ECE/TRANS/WP.29/GRSP/2012/21

Regulation 44

Proposal for Supplement 7 to the 04 series of amendments

Submitted by the expert from France

Test Description, overturning test tomorrow (proposal)

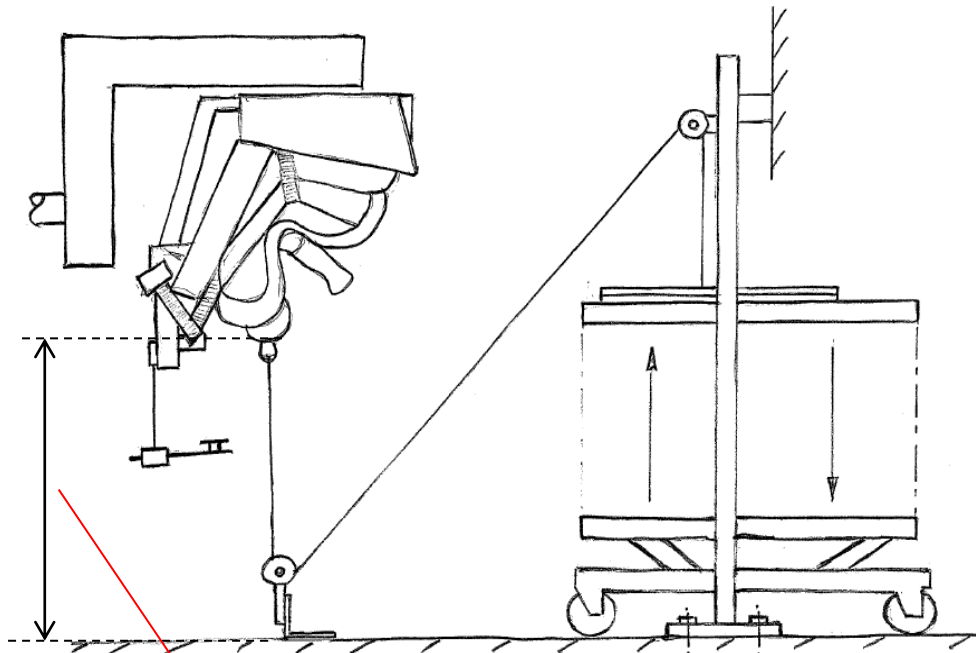
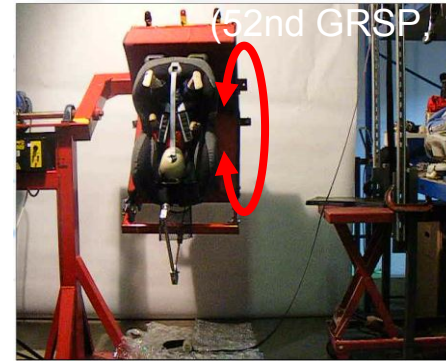
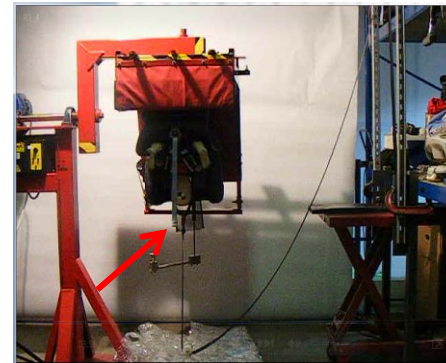
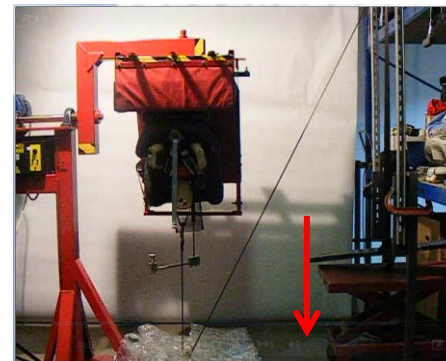
- The rotation angle will be increased to 540° , so that test seat and dummy stop in the upside down position.
- In this position a weight is applied as shown and described on the following slide
- Criteria remains unchanged

For proper working and testing: Approx. 800mm distance needed between dummy head and floor!

1.) 540° rollover test

2.) Attachment of additional weight (4 times dummy mass)

3.) Load applied at less than 400mm/min for 30 s – check of max head displacement

ECE R44 Overturning Test

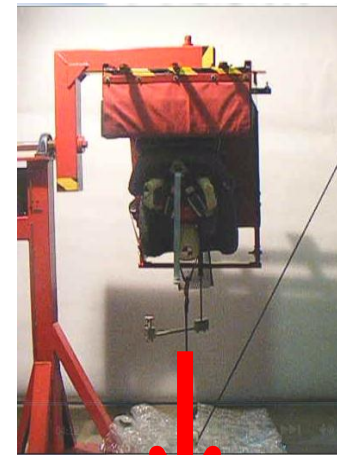
Pull force = 4 times dummy mass + origin dummy mass \triangleq 5g applied to restraint device

Load application device for Group 0/0+

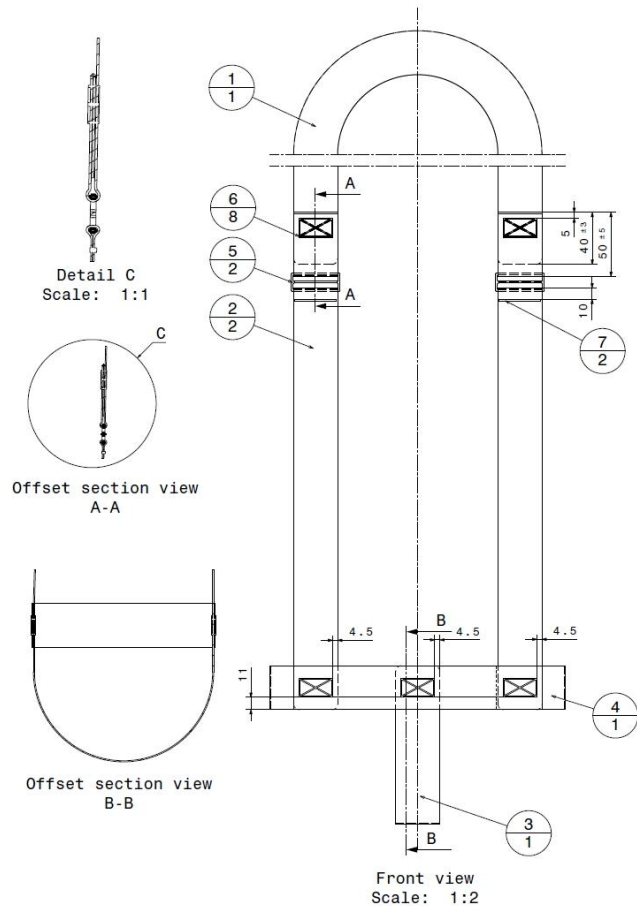
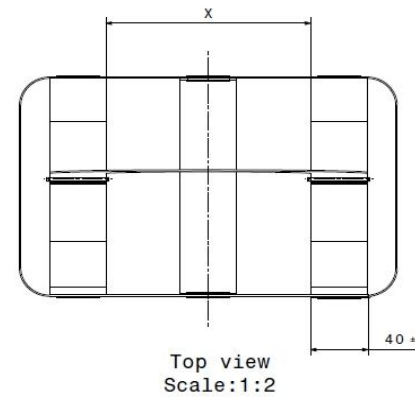
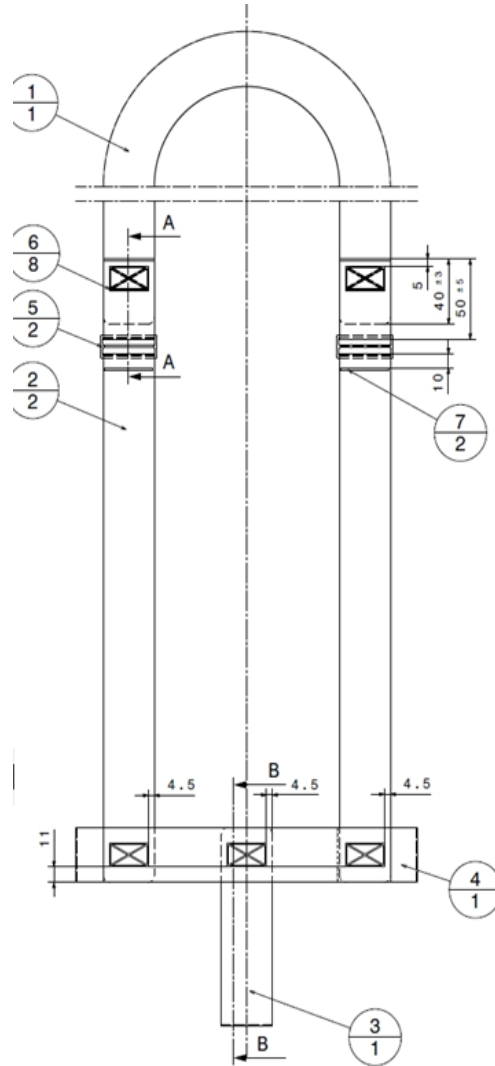
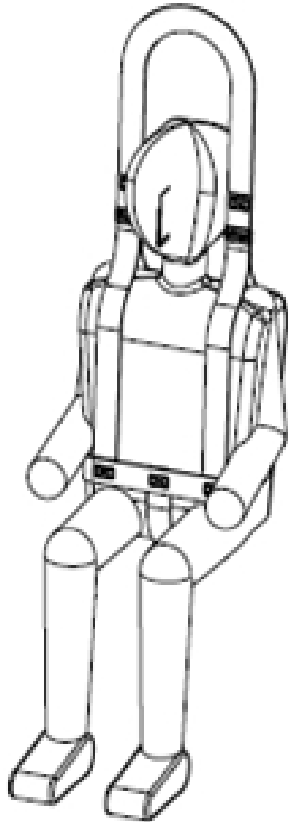
Insert a new Annex 23, to read:

Load application device for Group 1

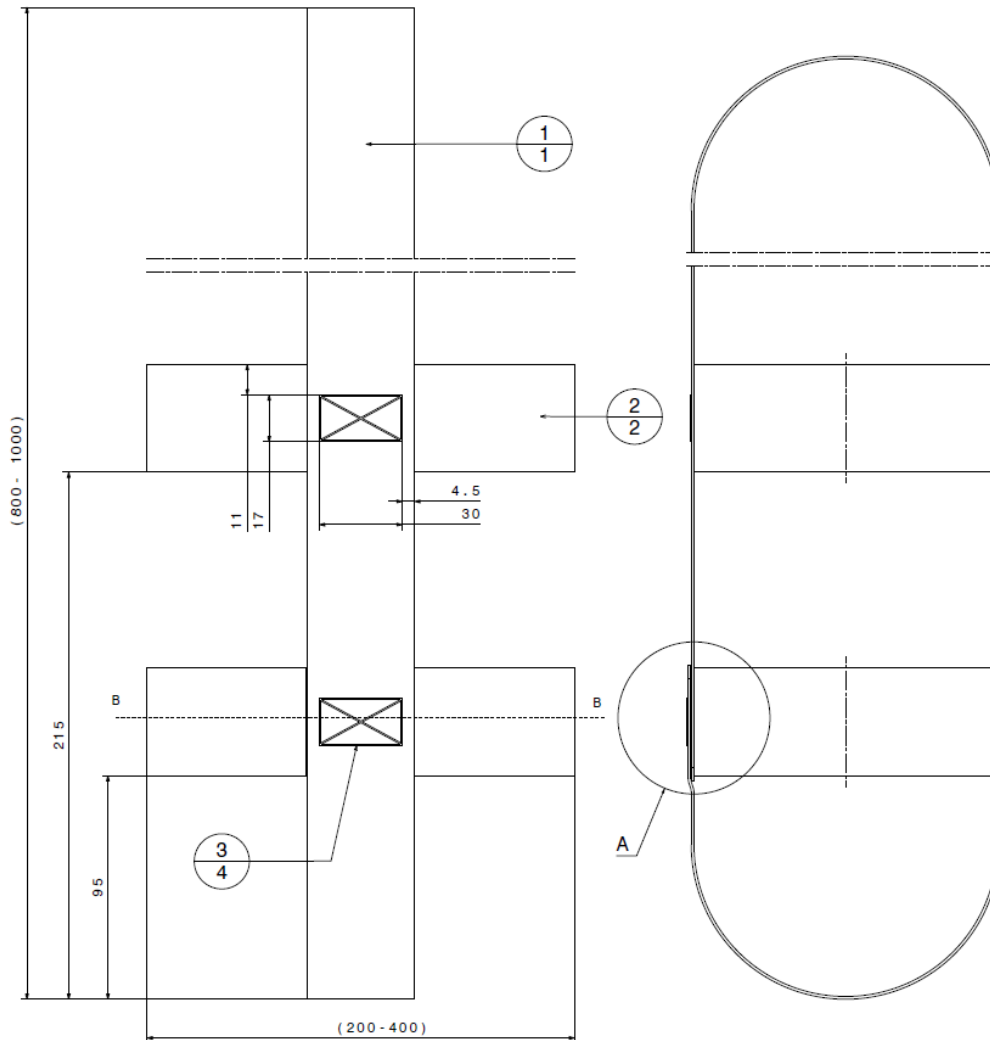
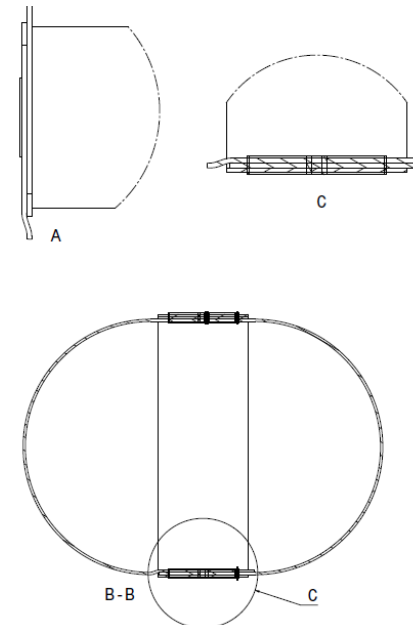
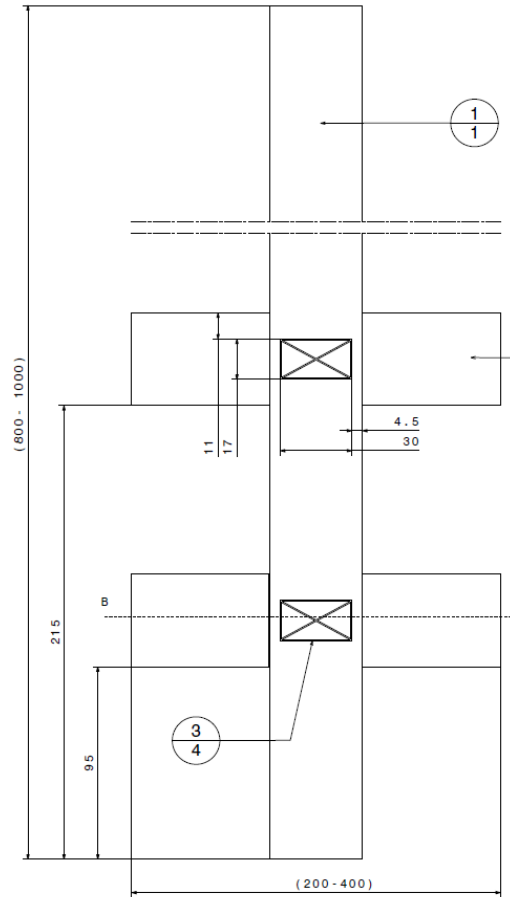
Insert a new Annex 23, to read:
